SERVICE BULLETIN

M-923

CLUTCH RELEASE COMPONENTS XL MODELS

Figure 1. Clutch Release Components

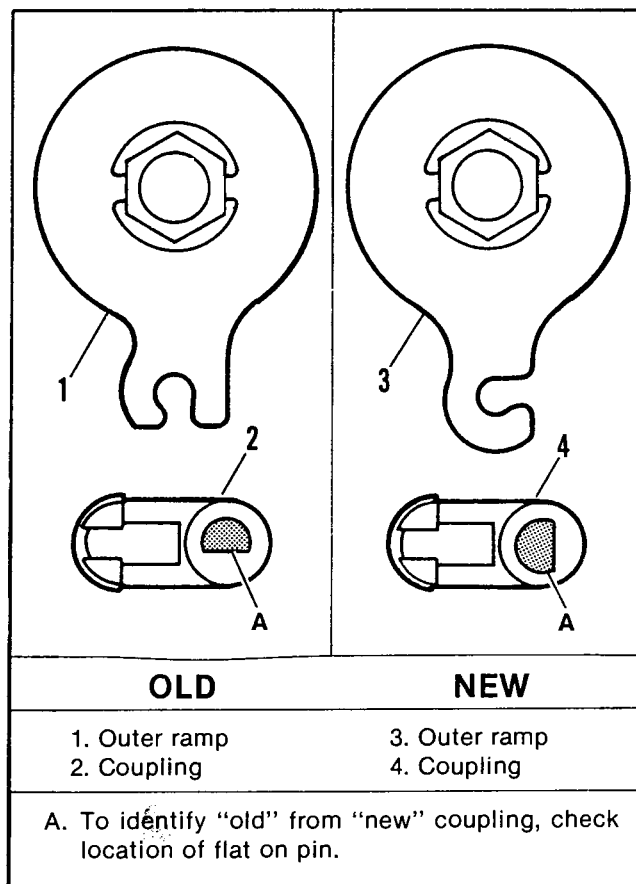
See Figure 1. Beginning with the crankcase numbers listed below, new outer ramps and couplings are being installed in the Sportster engines.

The new outer ramp and coupling will fit all alternator equipped Sportster engines.

The new outer ramp must only be used with the new coupling. If either the coupling or the outer ramp is replaced, both parts must be replaced.
